TOMAHAWK BBQ STEAKHOUSE  
INTERIOR REMODELING  
285 PARKWAY DRIVE LINCOLNSHIRE IL 60069

ISSUES	DATE
ISSUED FOR PERMIT	12/18/2022
REISSUED FOR PERMIT	03/10/2023

**PROJECT NOTES, SITE PLAN**

**C ACCESSIBLE SIGNAGE**  
NOT TO SCALE

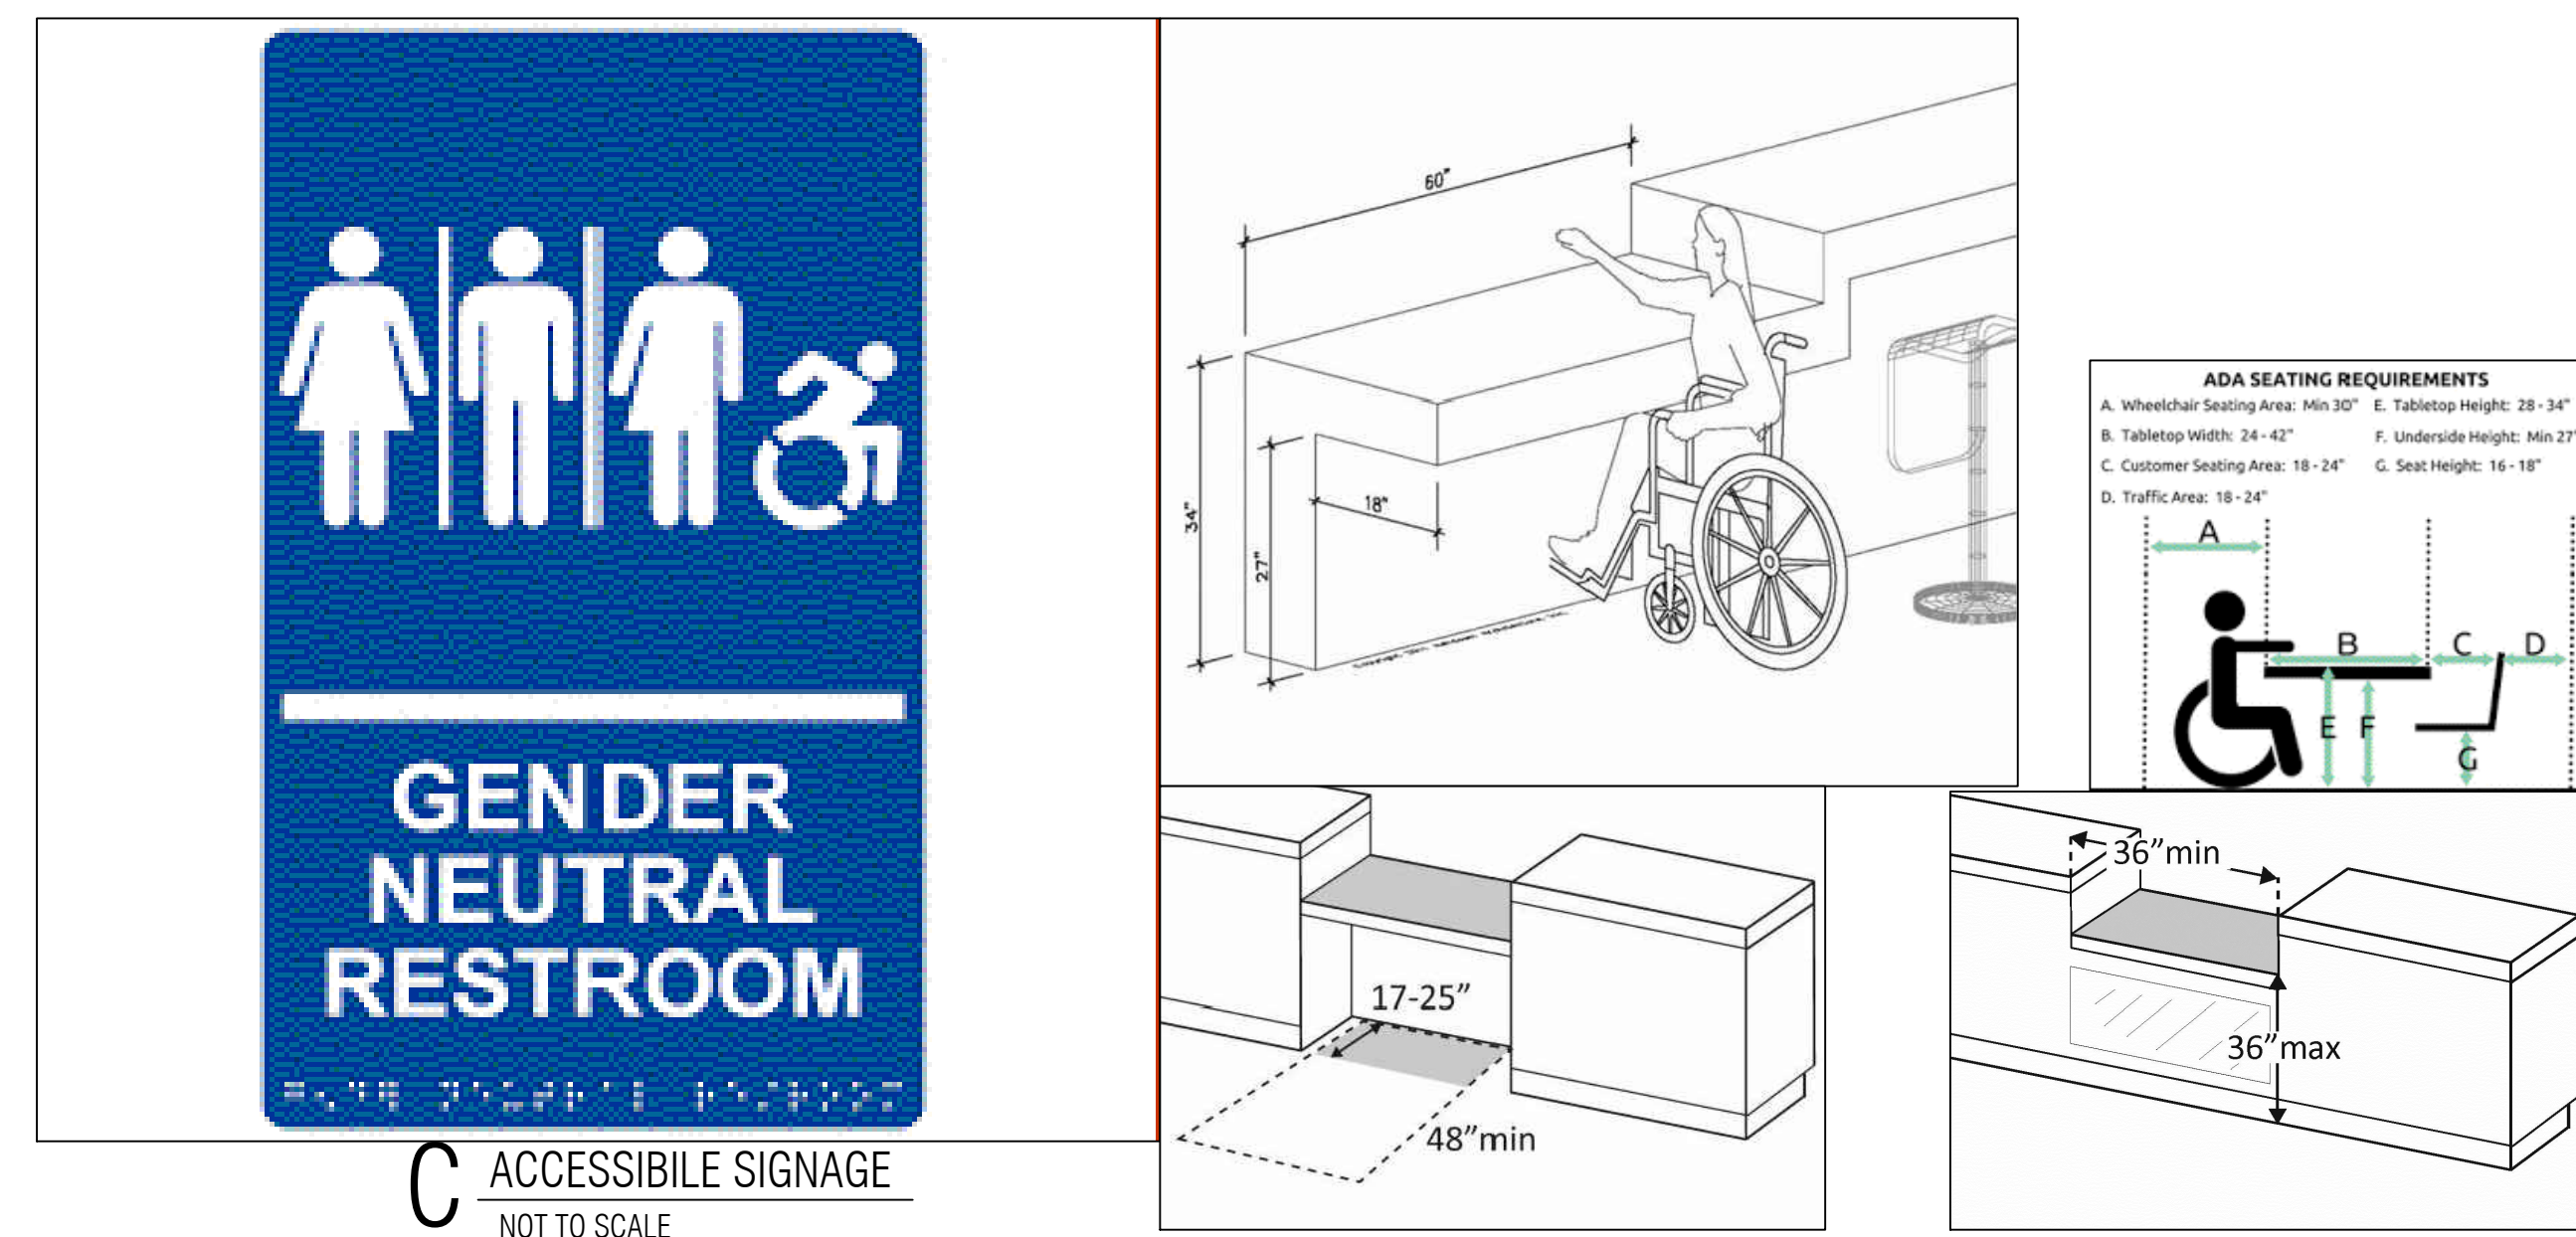
Restroom signage to meet 410 ILCS 35/25 requirements

**A** BAR AREA PLUMBING PLAN  
SCALE 1/4" = 1'-0"

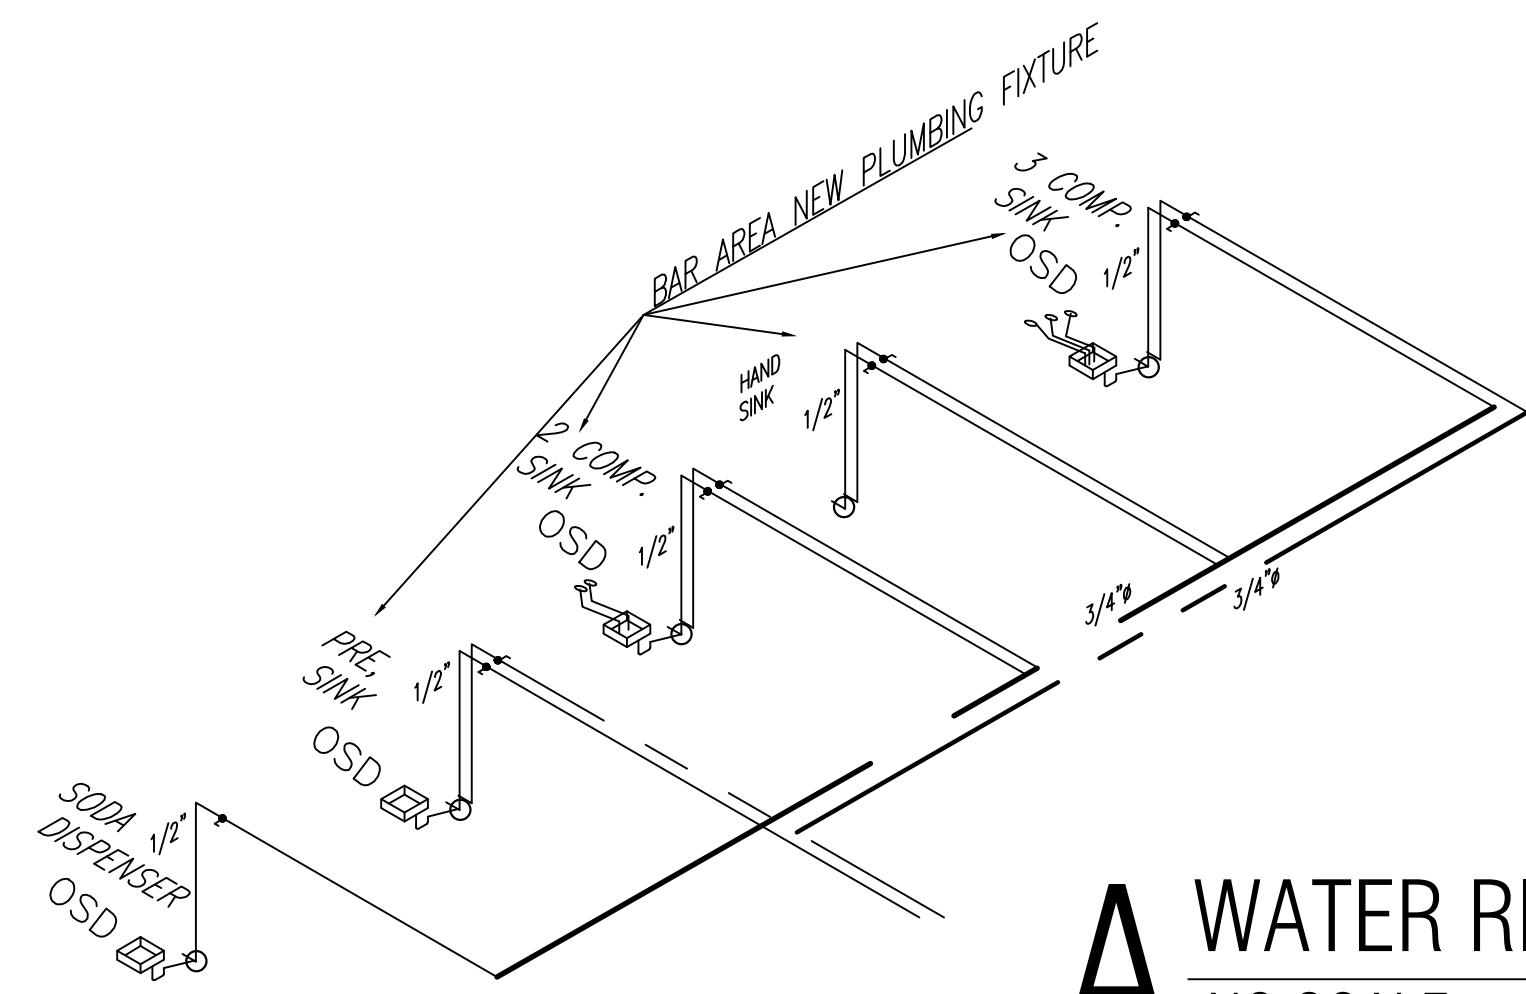
The plumbing inspector shall field verify each ice machine, coffee, tea, juices, or similar beverage dispensers supplied with potable water, shall be provide with an approved backflow preventer device appropriate for each type of machine. Note: The carbonated beverage dispenser shall have an ASSE 1022 or ASSE 1032 (with port) device in-line and the double check device shall be constructed of integral stainless steel materials.

2. The plumbing inspector shall field verify no more than twenty drainage fixture units (20 dfu) shall be installed on a two-inch (2") vent line
